Item 4.**Development Application: 21C Billyard Avenue, Elizabeth Bay - D/2019/665****File No.:** D/2019/665**Summary**

Date of Submission:	26 June 2019. Amended plans received on 23 October 2019 and 15 January 2020
Applicant:	Cracknell & Lonergan Architects
Architect/Designer:	Cracknell & Lonergan Architects
Owner:	Patrick Lane
Cost of Works:	\$385,000
Zoning:	R1 General Residential. The proposed residential use is permissible with consent.
Proposal Summary:	<p>Approval is sought for alterations and additions to an existing residential flat building comprising an additional storey containing a new living space and outdoor terrace to Unit No. 11.</p> <p>A total of 33 individual submissions were received following public exhibition of the application. Issues raised include view loss, detrimental impacts on the streetscape and character of the heritage conservation area, solar access, owner's consent, structural capacity of the existing building and reduced access to the roof top.</p> <p>The application is referred to the Local Planning Panel for determination as it is contentious development, being a development receiving 25 or more unique submissions by way of objection.</p> <p>The

Figure 12: South elevation of existing building and proposed addition showing setback from Onslow Avenue and additional height in storey

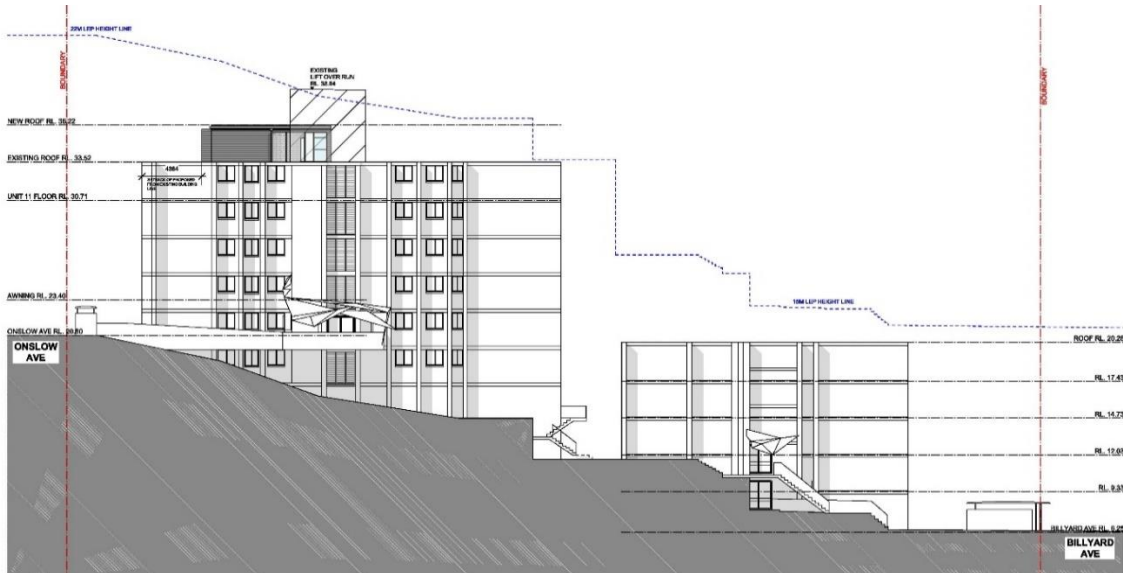
39. The proposal increases the building height in the middle of the building from six to seven storeys. This is acceptable from a streetscape point of view as the proposal will not be overly visible from Onslow Avenue or Billyard Avenue, and the increased height in this location is adjacent to the existing lift overrun (Figure 12).
40. As discussed above however, it is unclear whether this height in storeys non-compliance can be supported from view sharing or view corridor perspectives.

41. Following a review of the original proposal by the City's Heritage Specialist and Urban Designer, a number of concerns were raised with regard to materiality. The originally proposed materials, which included marble cladding, tile cladding and zinc, were out of character with the existing building, which is primarily constructed of brick and render. The application also lacked detail regarding materials, colours and finishes.

42. The application was amended to simplify the proposed material palette to better align with the materials of the existing building and surrounding conservation area, as well as provide addition details on proposed colours and finishes.

43. The revised proposal is acceptable. The refinement of materials combined with the considerable setback of the addition from Onslow Avenue results in a building that is not inconsistent with the streetscape and will not detract from the heritage conservation area.

Figure 14: North elevation of Darnley Hall showing additional overshadowing at 1:00pm on 21 June

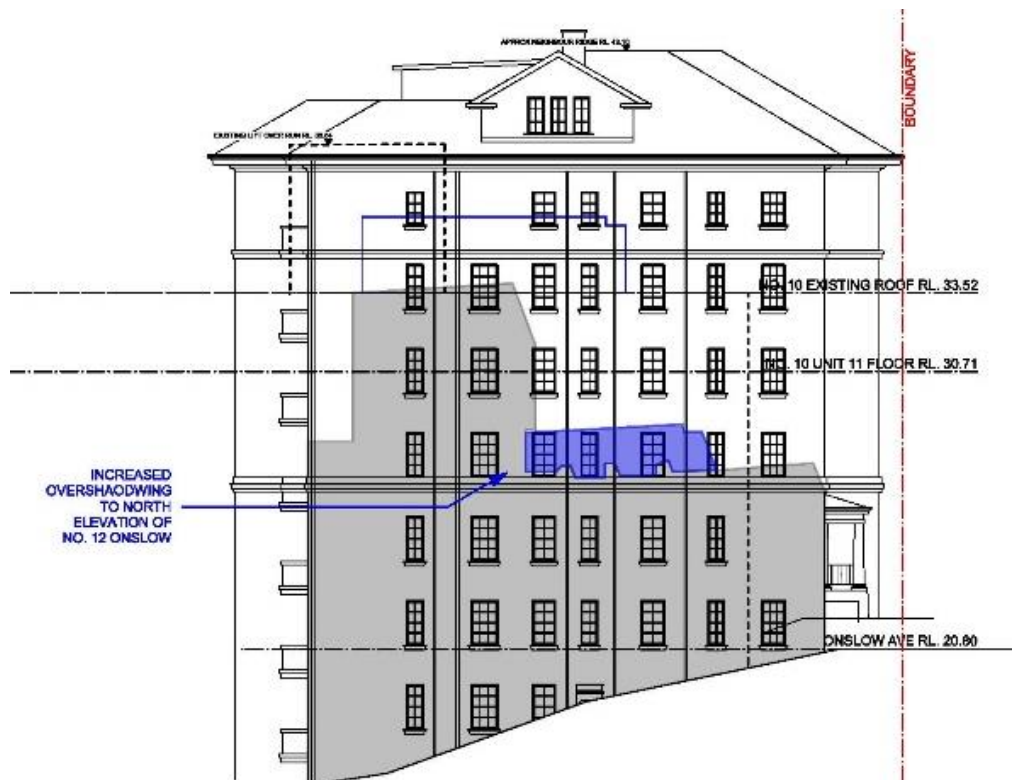
46. The shadow study demonstrates that overshadowing to Darnley Hall will not result in unacceptable impacts and is acceptable as follows:
- (a) Living room windows and private open space areas are either orientated to the north east towards the harbour, or to the south west towards Onslow Avenue. Floor plans do not show these areas located on the northern elevation.

- (b) Windows located along the northern elevation are to bedrooms, kitchens laundries and bathrooms.
 - (c) The elevation shadow study shows that three windows will be impacted by additional overshadowing in the afternoon for one hour between 12.30pm and 1:30pm.

- (d) The overshadowing of these windows is acceptable as these windows are not to living rooms and are therefore not protected from overshadowing under the DCP.

- (e) Further, these windows still receive a minimum of 2 hours of direct sunlight to a significant portion of the window between 9am and 3pm on the 21 June.
